Access Compliance Report

Public Rights-of-Way

(Pedestrian Signals)

Intersection ID: N/A	Main Street:	Cross Street: N/A	Location: N/A
ADA ID: 47DC9CE32559	Signal Type: One Push Button-Non APS	Overall Compliance: No	Severity Score: BTN 1: N/A BTN 2: N/A No BTN: N/A
Codes/Mitigation Info/Possible Solution		Field Measurements/Component Compliance

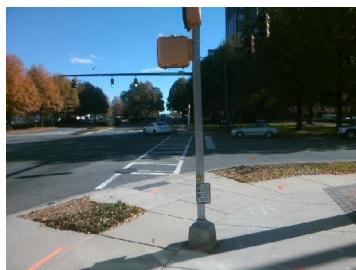
Yes	B 1 Clear Xing Direction?	ClearlyMarked	N/A	B 2 Clear Xing Direction?	N/A
	B 1 Crossing Direction	To NE		B 2 Crossing Direction	N/A
Yes	B 1 DistanceTo XWalk (in)	0.0	N/A	B 2 DistanceTo XWalk (in)	N/A
No	B 1 DistanceTo Curb (in)	172.0	N/A	B 2 DistanceTo Curb (in)	N/A
Yes	B 1 Diameter (in)	2.0	N/A	B 2 Diameter (in)	N/A

Possible Solutions: Replace Signal Push Button With APS Button on New Post. Remove & Relocate Sign.
